TXDOT AVIATION STATEWIDE AIRPORT ELECTRICAL CONSTRUCTION PROJECT (AVSAE) - GROUP ALPHA
TxDOT CSJ No. 4222AVSAEA

ADDENDUM NO. 3

May 14, 2025

1 / EG4.3 **VAULT POWER PLAN**
SCALE: 1/2" = 1'-0"

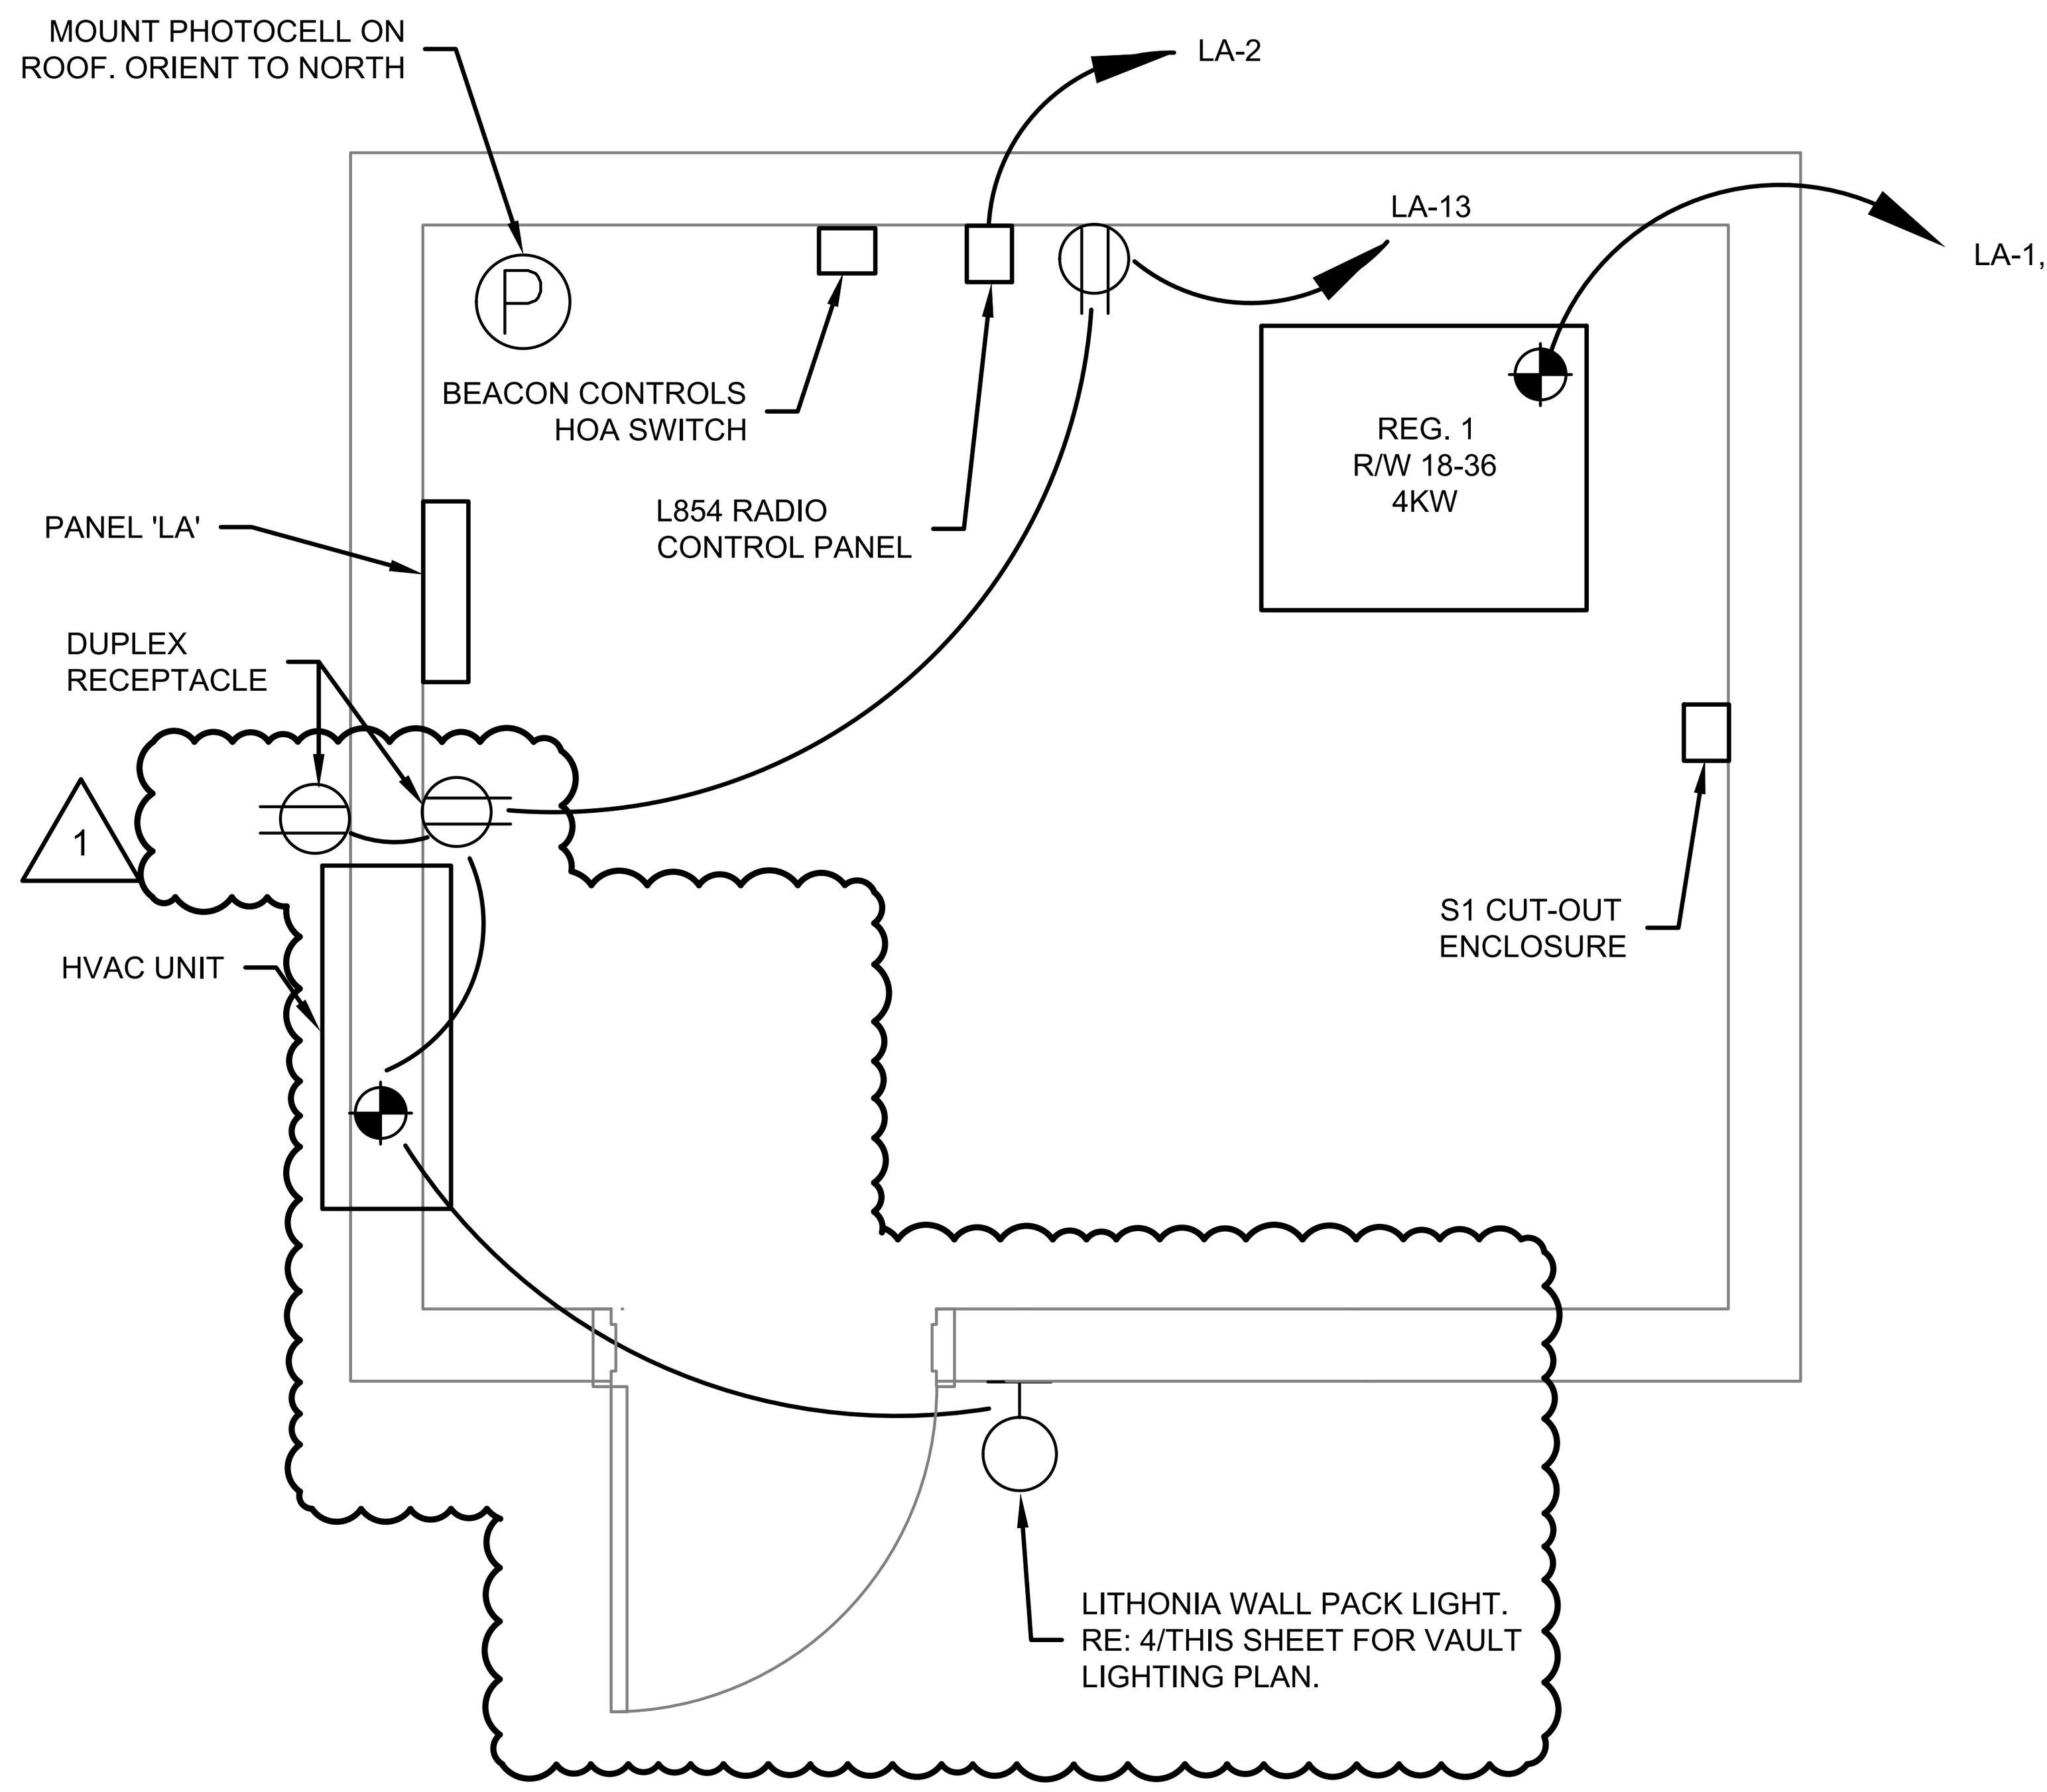
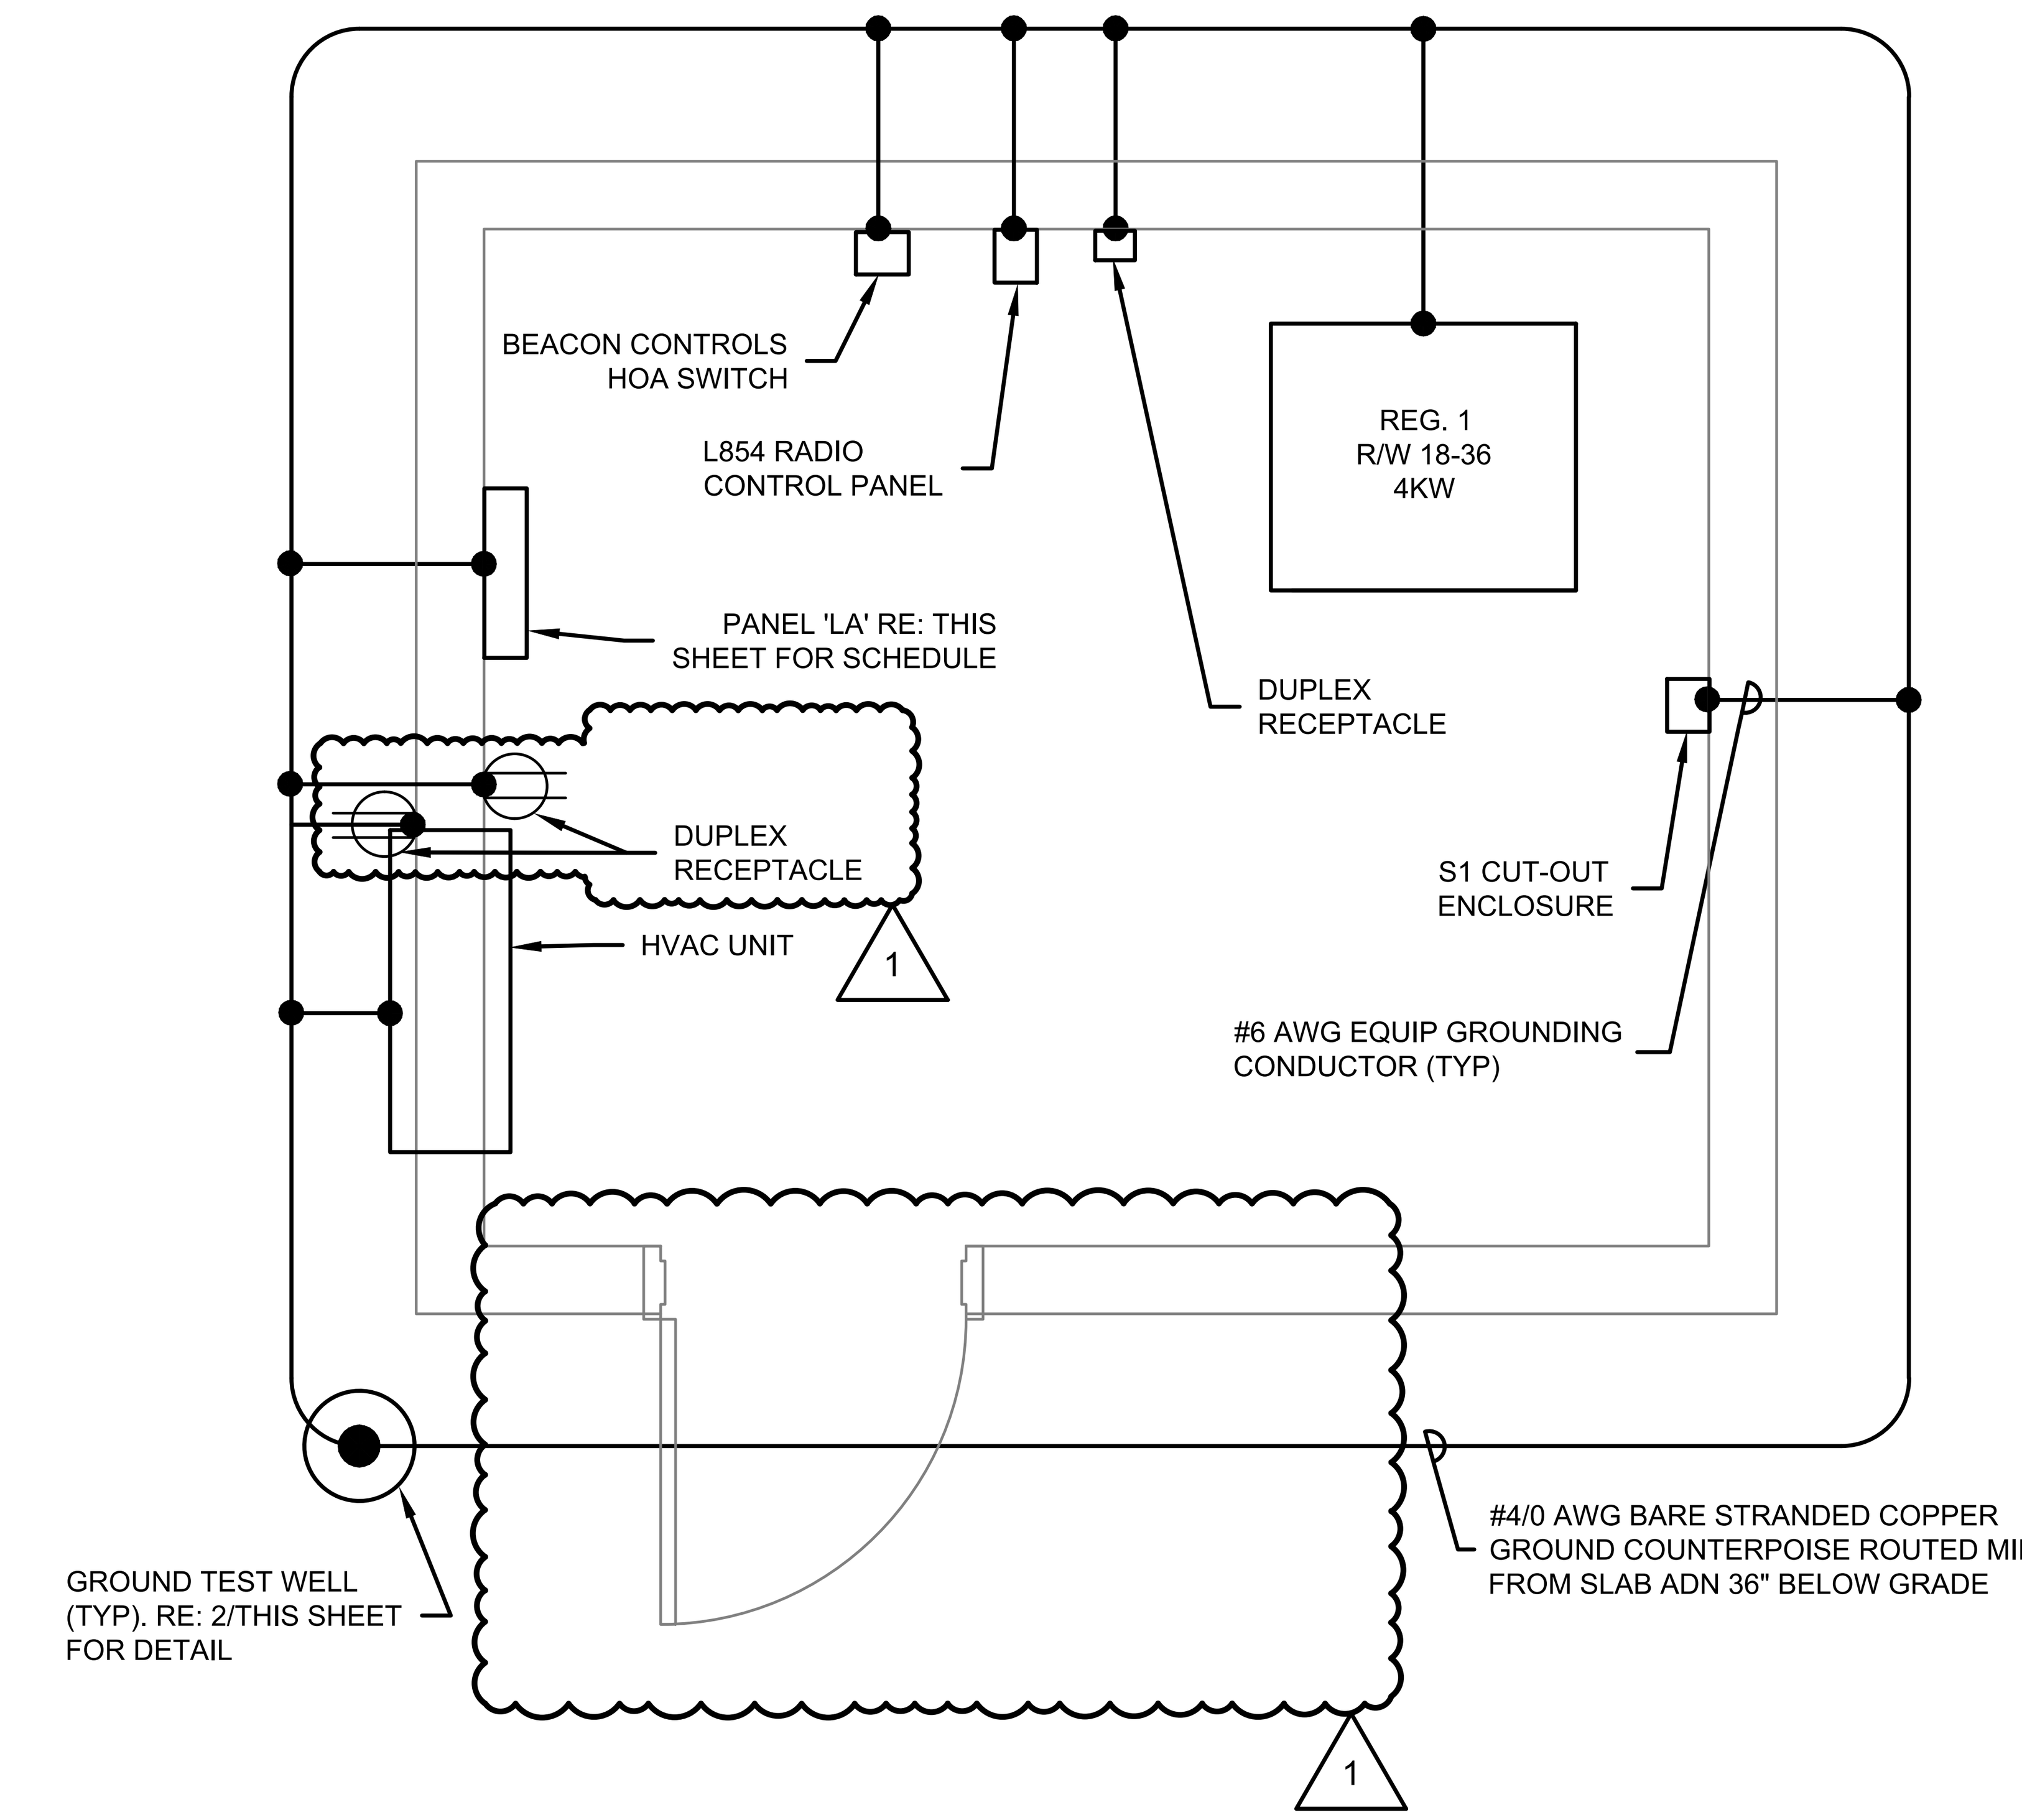
v) **Sheet EG4.3 –Electrical Vault Plan. Revised details to update the vault power plan, vault grounding plan, and vault lighting plan.**
w) **Sheet EG6.1 – Airfield Lighting Schedules. Revised Edge Light Fixture Schedule.**
